CITY OF DULUTH
Community Planning Division

File Number	PL 18-122	Contact	Jenn Reed Moses	
Type	MU-W Planning Review	Planning Commission Date	November 13, 2018	
Deadline for Action	Application Date	September 20, 2018	60 Days	November 19, 2018
	Date Extension Letter Mailed	October 1, 2018	120 Days	January 18, 2019
Location of Subject	1033 Minnesota Avenue			
Applicant	Park Point Marina Inn and Suites LLC	Contact	Terry Anderson	
Agent	N/A	Contact	N/A	
Legal Description	010-4390-02090, 010-4400-00780			
Site Visit Date	October 2, 2018	Sign Notice Date	September 25, 2018	
Neighbor Letter Date	October 1, 2018	Number of Letters Sent	23

Proposal

The applicant is proposing a 3 story, 6,100 square foot, 15 room addition to the southeast side of the existing hotel. Staff has revised the report and proposed conditions since the October 9, 2018 Planning Commission meeting where the Applicant's request was tabled.

1 PARKING 30% SHADING AREAS
L-3 SCALE: 1"=30'

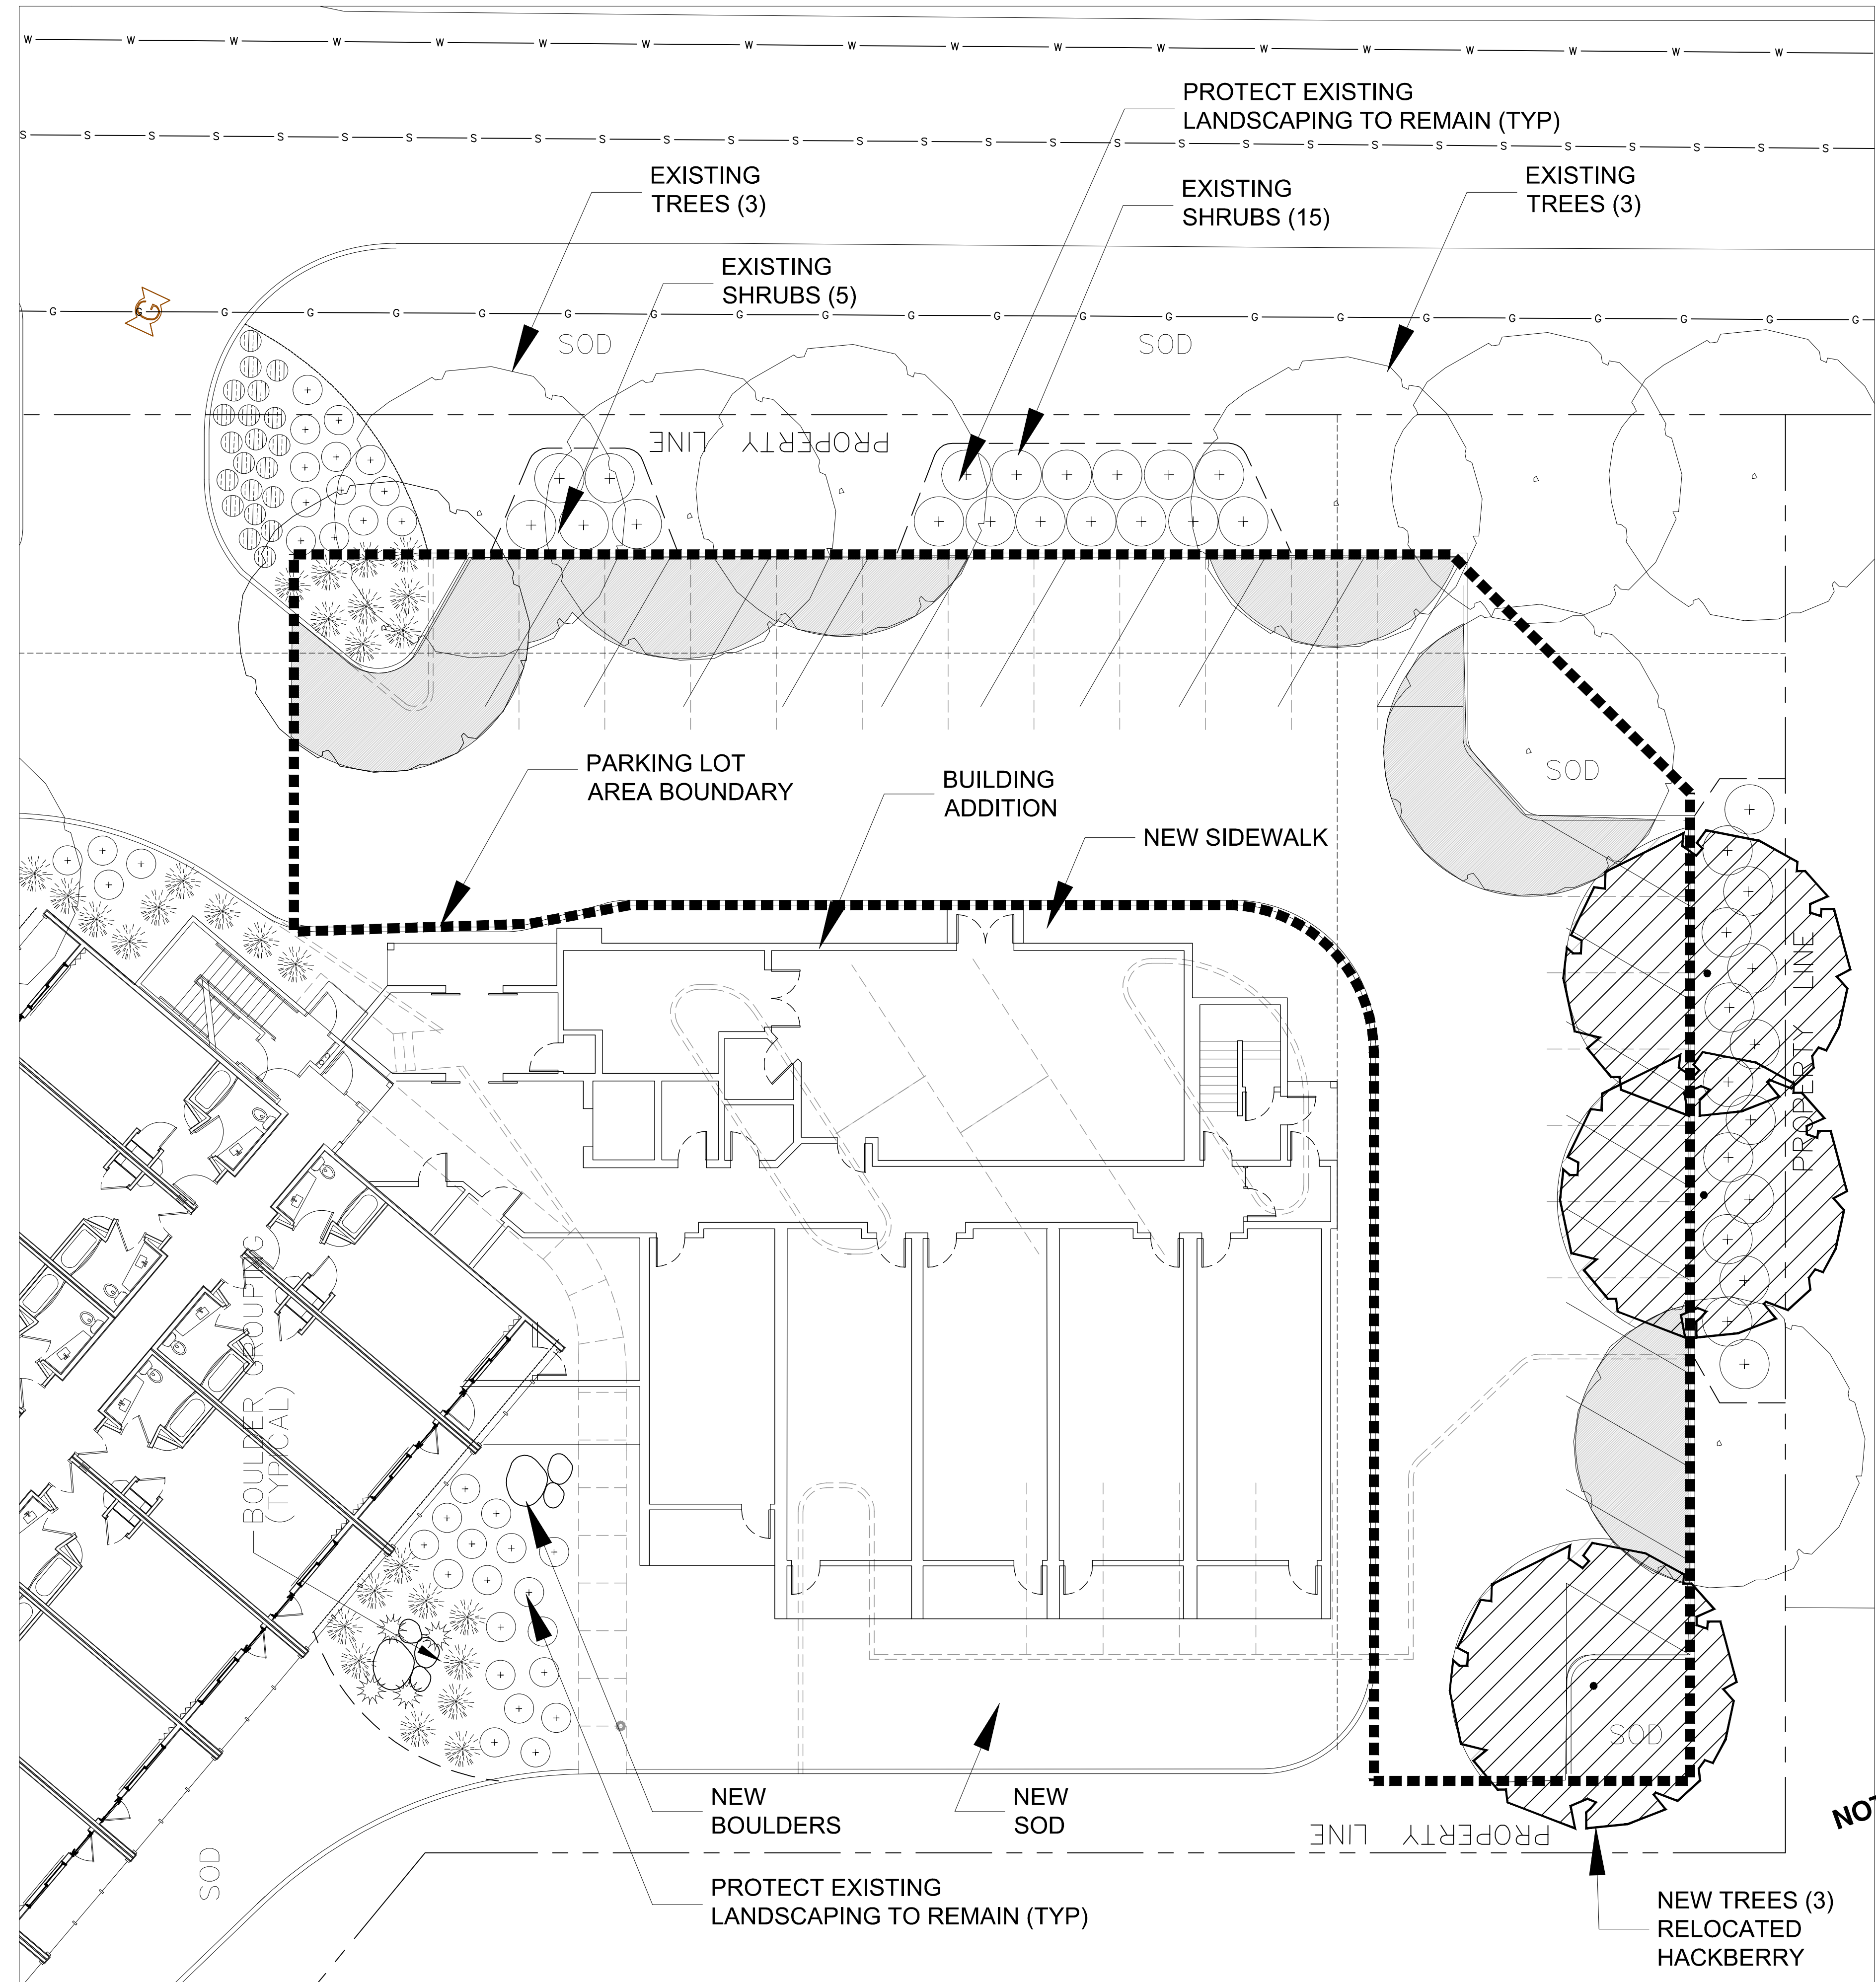
- 7) 50-25 (Landscaping and Tree Preservation) - Landscape Plans indicate that the proposed expansion project will provide the required tree canopy coverage and frontage landscaping requirements.

PROPOSED ADDITION - HARBOR ELEVATION

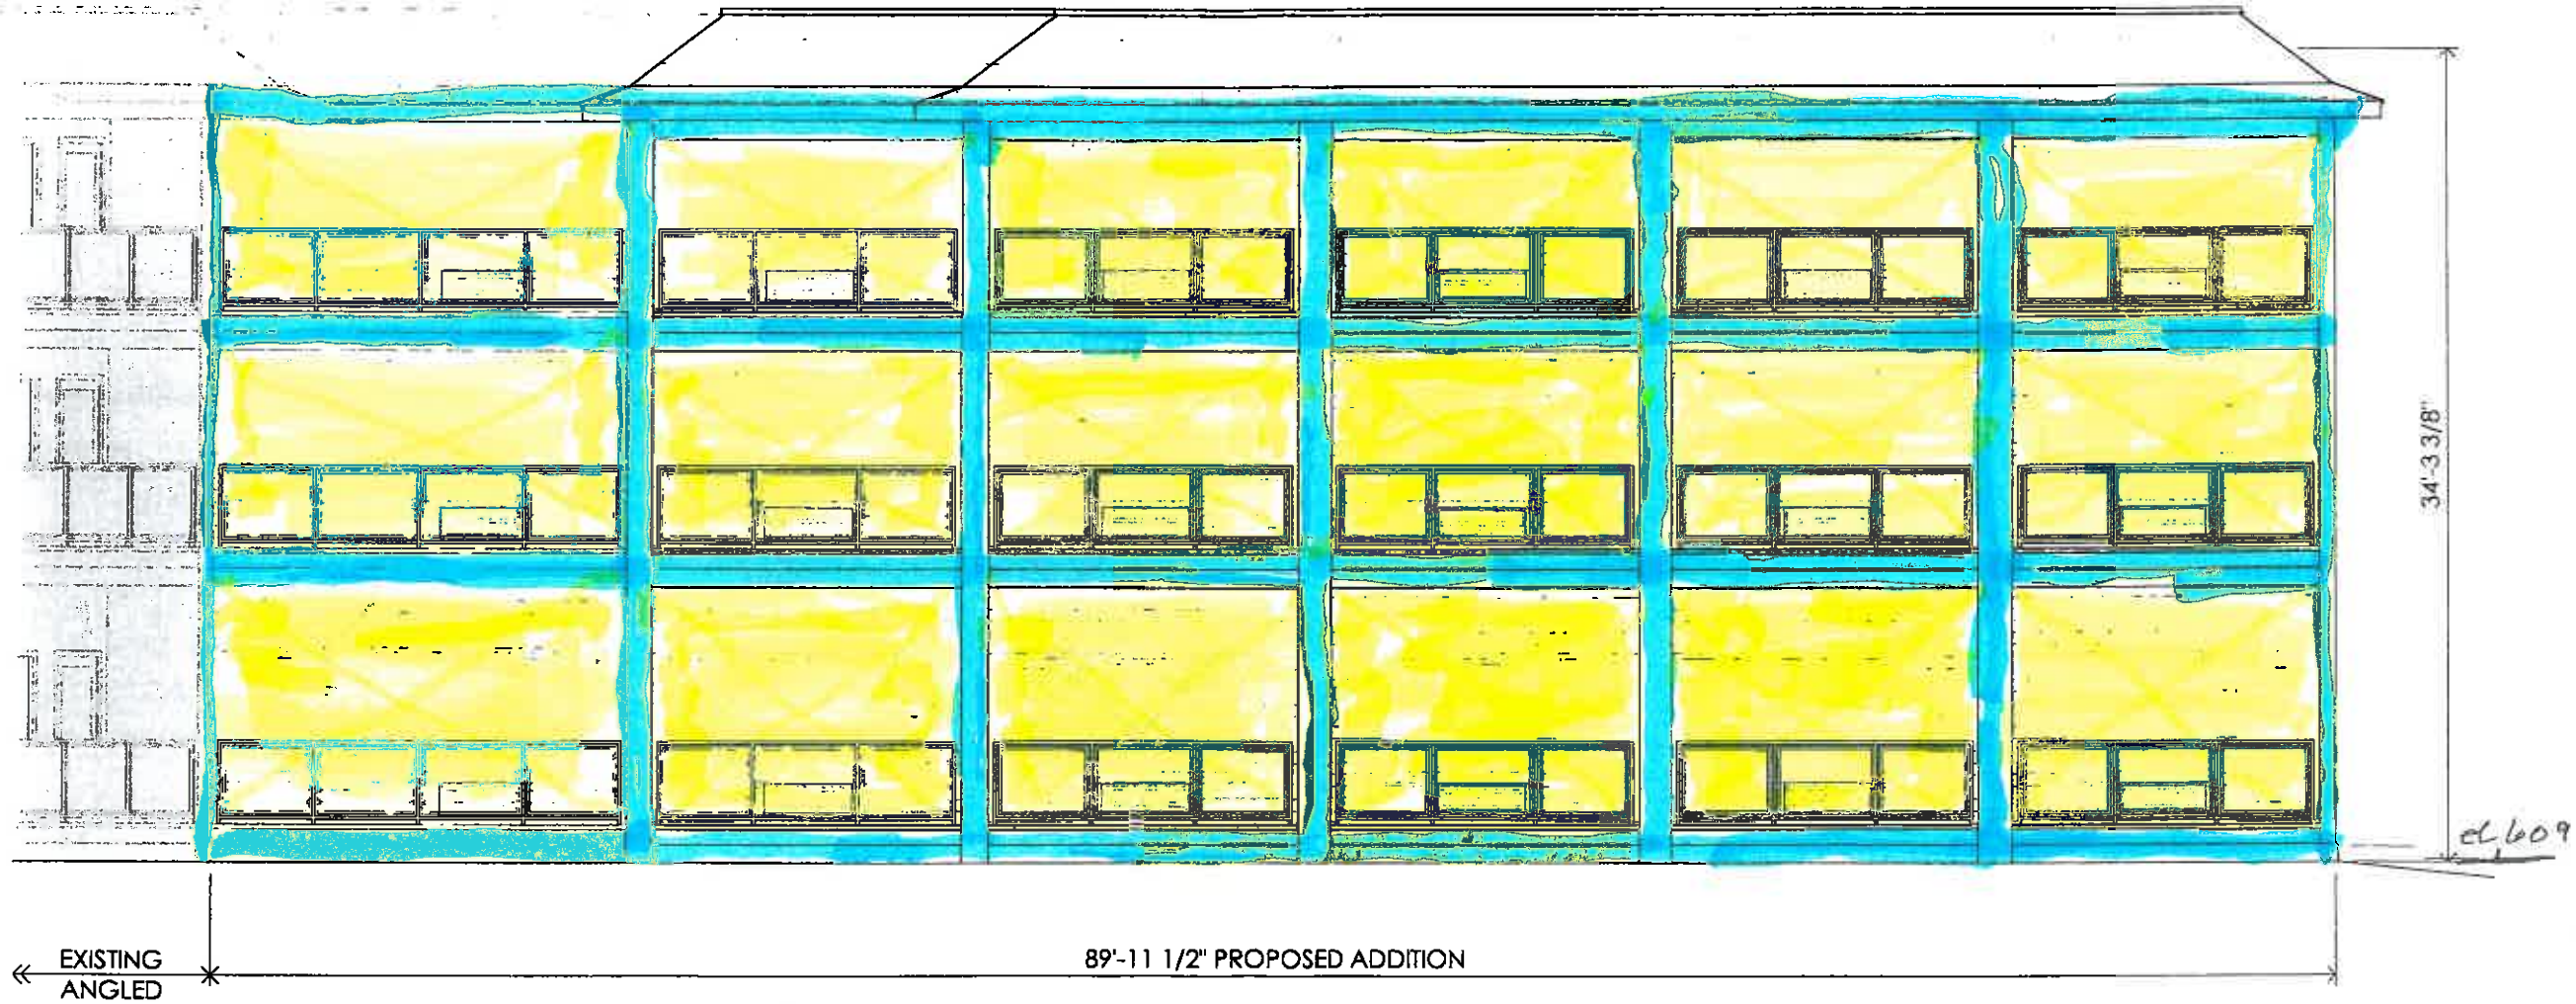
- 3) 50-15.6.E (Development Standards) – #2 The proposed expansion will meet the required minimum 50 foot setback from adjacent structures. #4 Applicant states the project will meet the minimum 40% transparency requirement along the waterfront. #5 The proposed expansion will add rooms and take away existing off-street parking spaces; see item 5 below.

3. Prior to issuance of a building permit, Applicant shall submit professionally drawn elevations signed by a Licensed Architect that include measurements demonstrating that the façade facing the water meets the 40% transparency requirement of the UDC.
